# VALUE ENGINEERING STUDY

Tres Rios  
Phoenix, AZ

## Final Report

September 2000

H-28

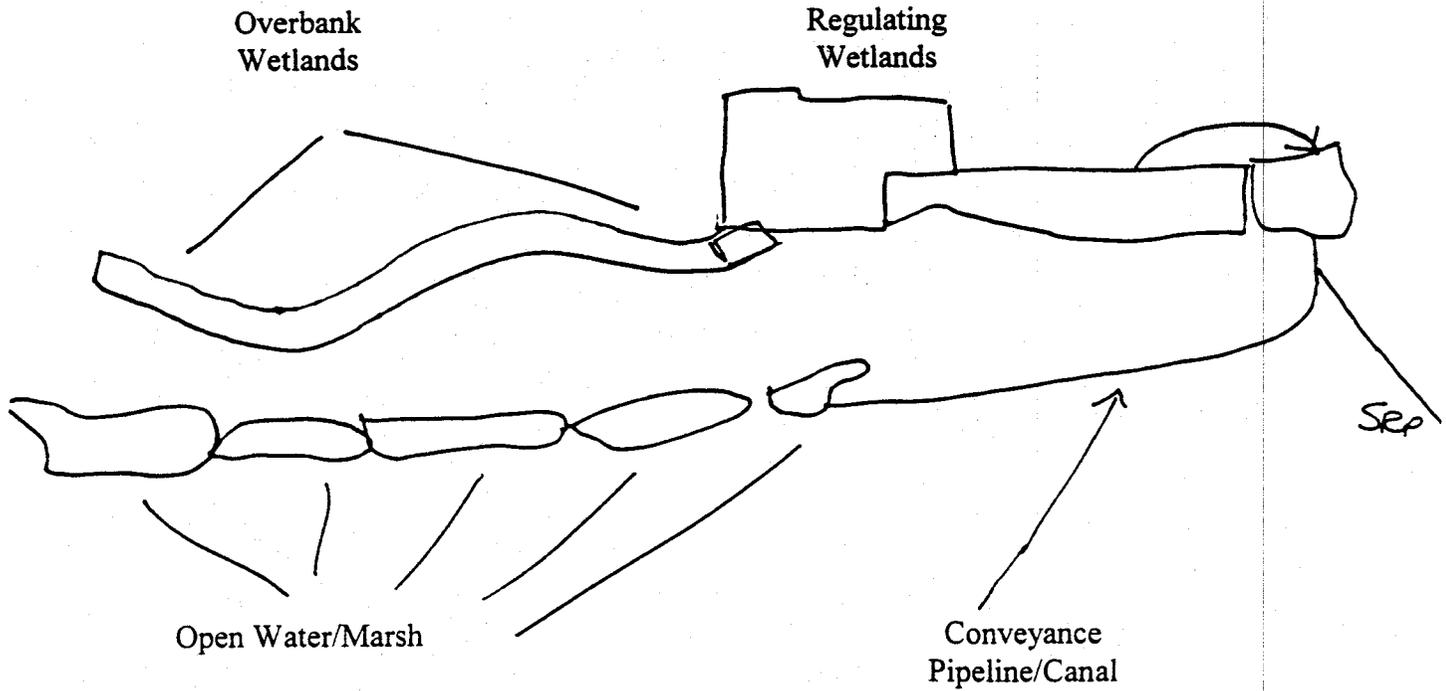
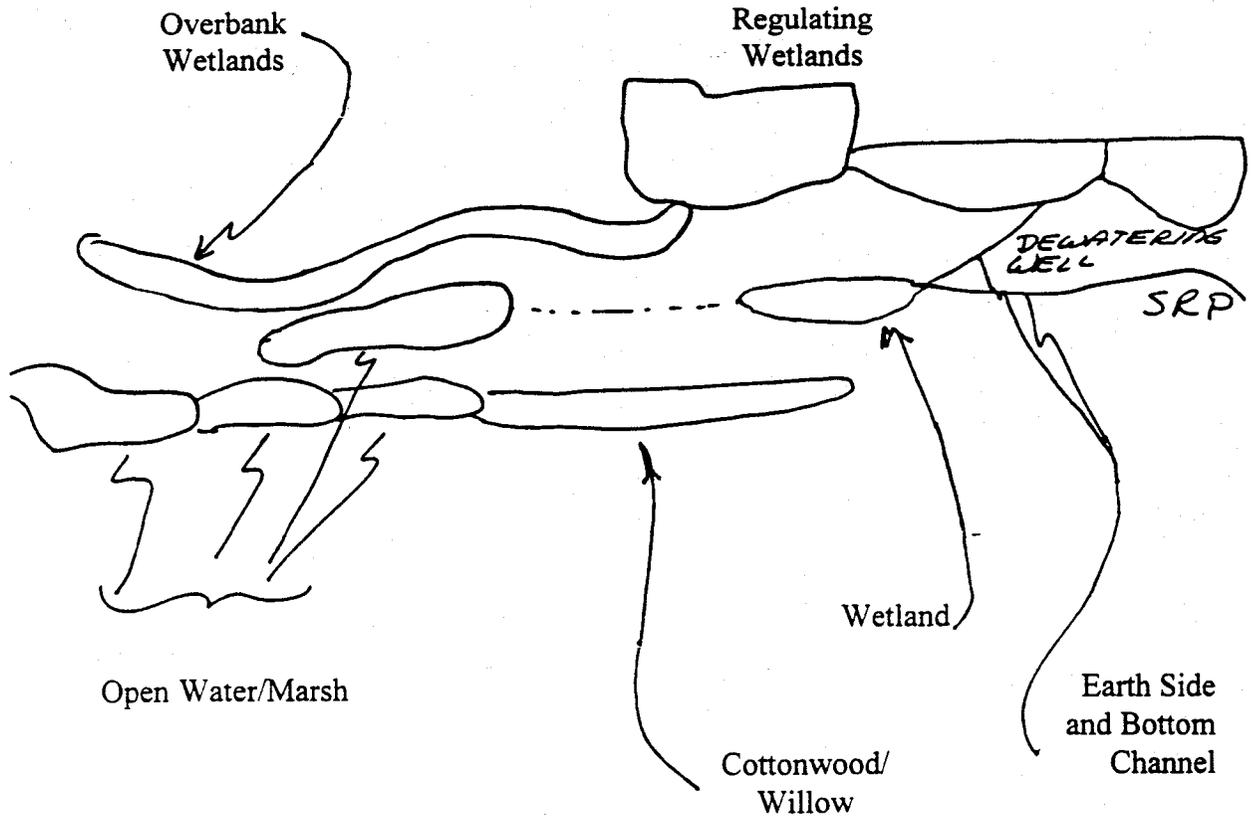
The proposed change provides improved conveyance and sediment transport while achieving a more natural flow and habitat configuration.

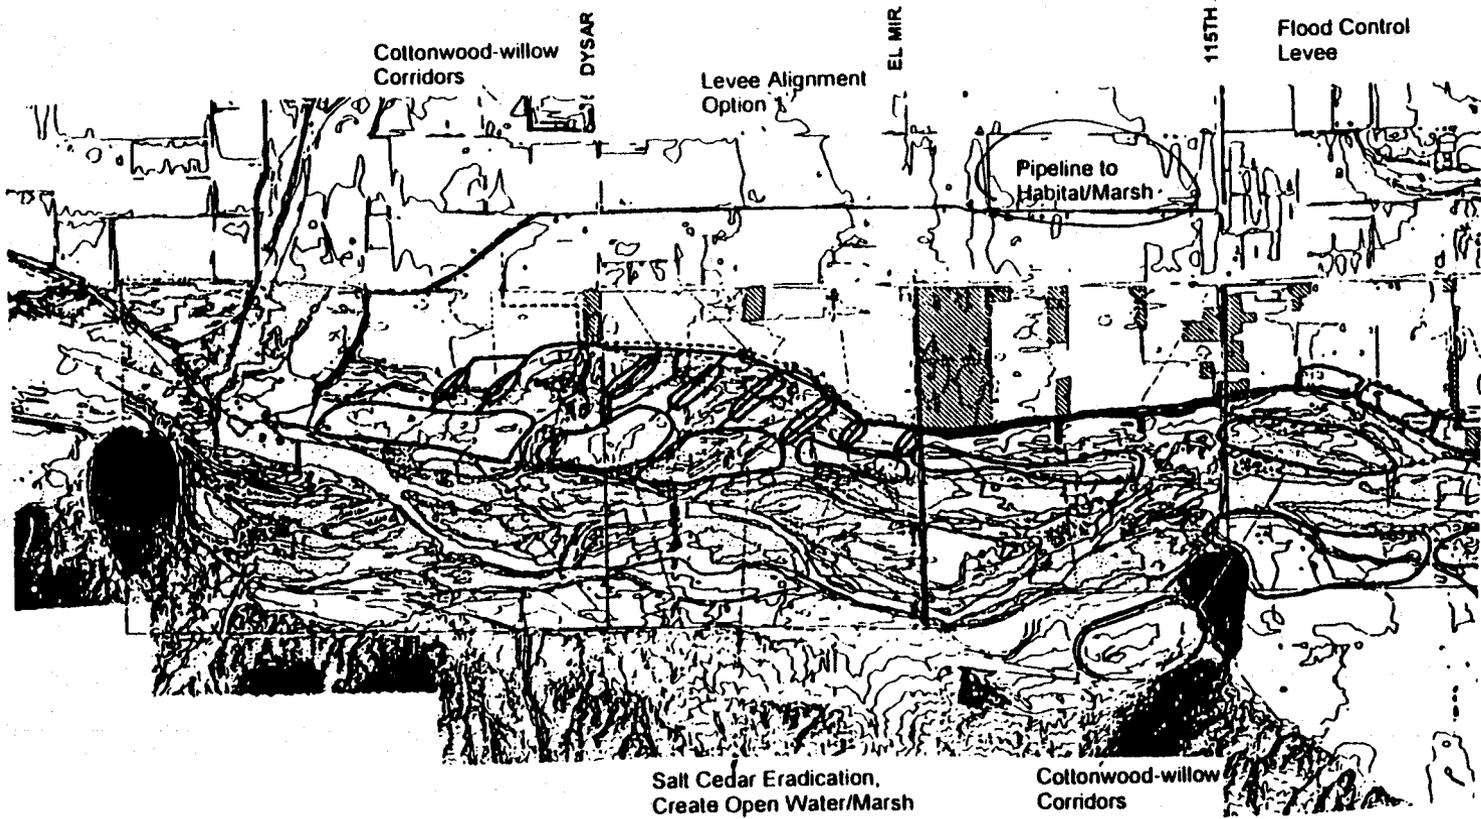
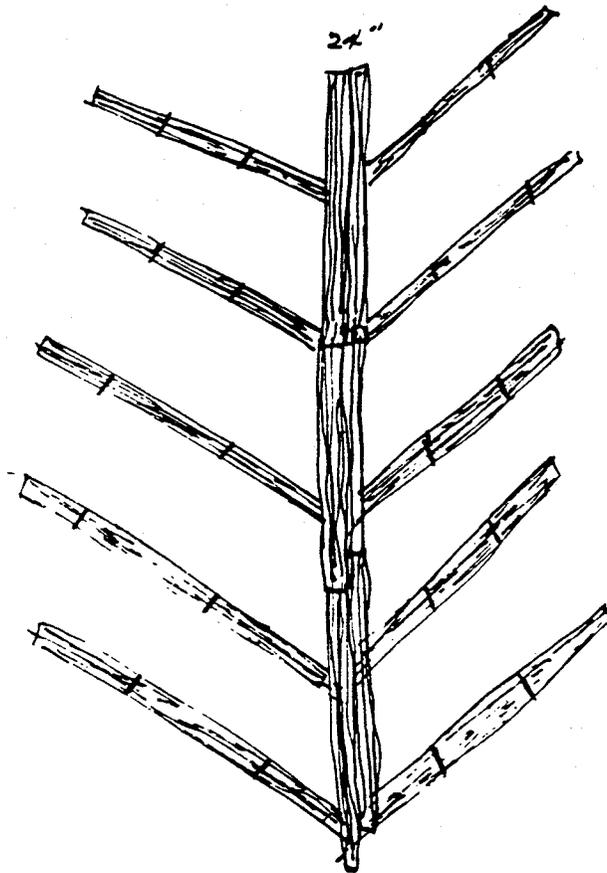
The proposed concept would eliminate the pipe and discharge water directly to the river from the overbank wetlands. The downstream north bank has areas of seepage. Planting moist areas with cottonwood/willows as planned would achieve habitat. If drier areas are encountered farther uphill, mesquite bosques would be planted.

In this recommendation, the cottonwood/willow habitat is established without permanent supplemental water from the overbank wetlands. In the original concept, the water was delivered to the cottonwood/willow stringers to eliminate perched surface water and encourage drainage; thereby eliminating an existing vector problem. In the proposed concept, surface drainage is accomplished by dense willow plantings or fascines. The rapid growth of willows and their fine shallow roots provide surface drying without interfering with the deep buttressing root architecture of the cottonwood. If very seepy areas are encountered, the willow fascines can be arranged in pole drain configuration. This approach maintains the desired riparian habitat while simplifying the design. This results in a more robust self adjusting system.

PROPOSAL NO.: H-58

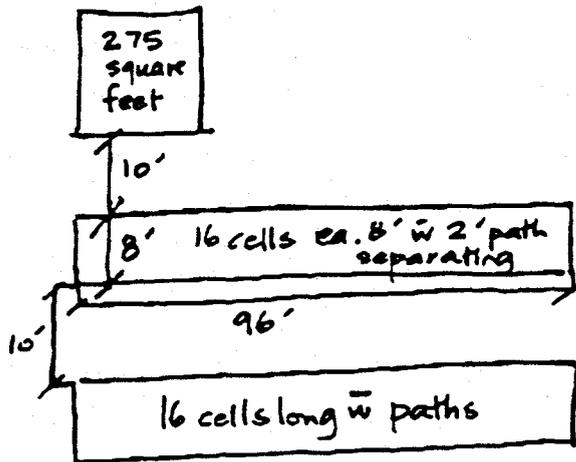
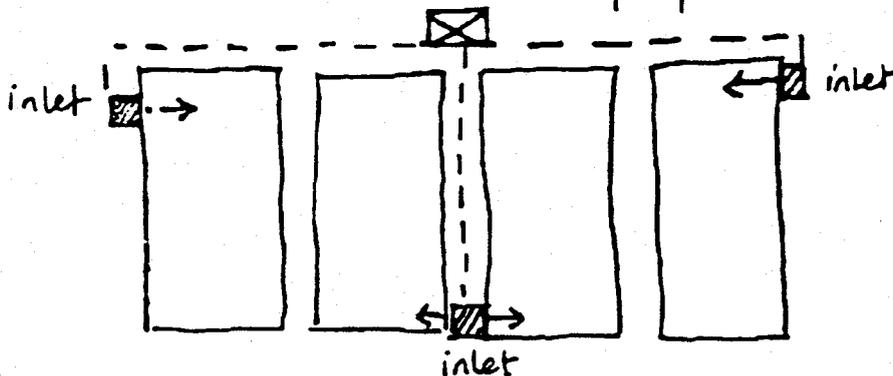
The proposed concept would be to develop a plant nursery to propagate both wetland and riparian desired species for project construction and operation and maintenance needs in the future. Surplus would be available to other local projects and would create a revenue source to offset continued operation and maintenance costs.

The value team believes that the creation of a wetland and riparian plant nursery for the Tres Rios project and other associated projects would be very cost effective. The species of vegetation to be used can be controlled and the quality assured. Replacement vegetation that has died or is experiencing stress can be quickly replaced. Other City of Phoenix riparian habitat projects as well as city parks and other governmental agencies can benefit. Not only will the initial vegetation costs be saved, but also the annual O&M costs can be saved.

One of these locations should be as close as possible to the Visitor's Center

Cells to be flood irrigated with species appropriate substrate

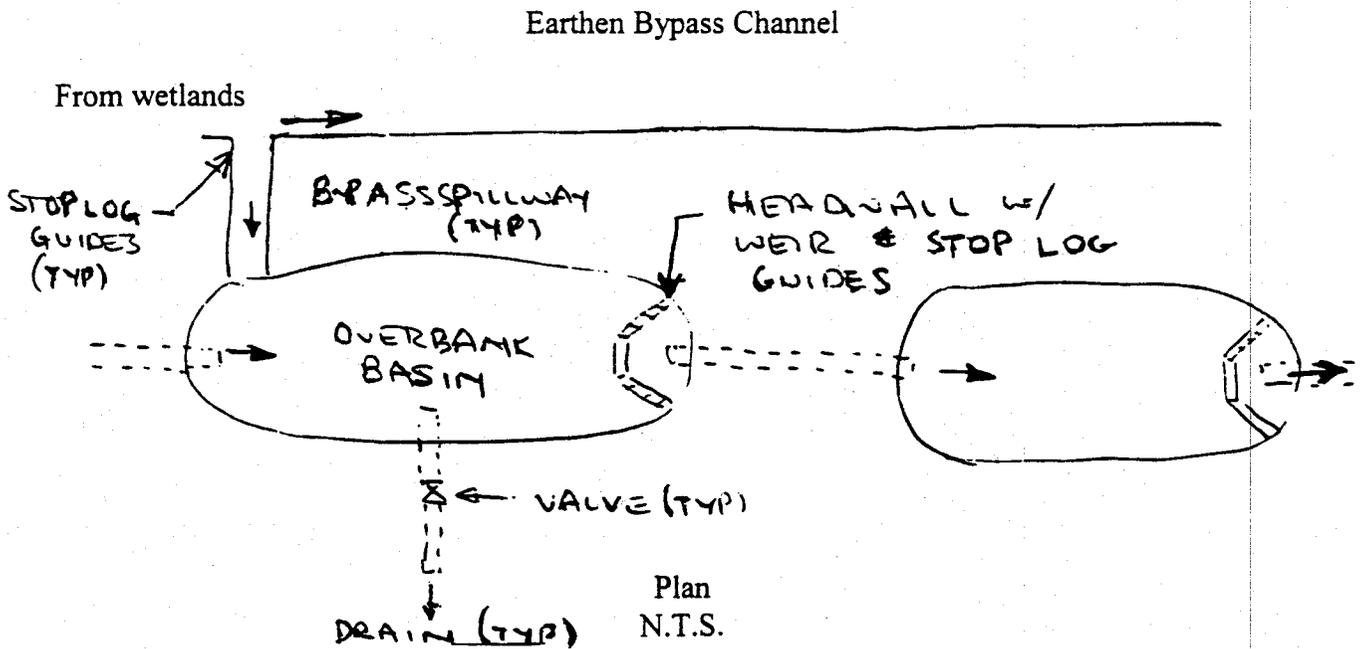
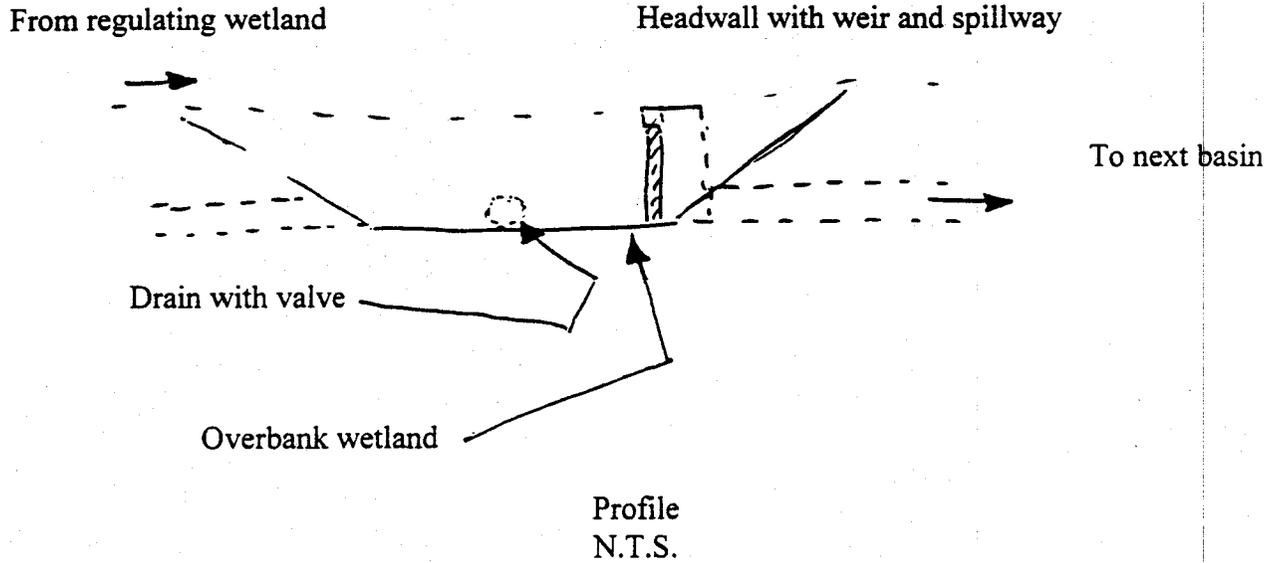
For the overbank basins, a single control gate at the regulating basin would be installed to modulate flow to these basins. Drain valves on basins are still required but pinch or eccentric plug valves may prove better than gate valves due to solids handling and reduced sticking potential. The flow from basin to basin would be via a static headwall with overflow weir to a pipe. A bypass channel would permit bypassing of any or all basins. Stop log guides in each weir would also facilitate single-basin maintenance. Spilling over headwall could add dissolved oxygen to water and waterfall sounds.
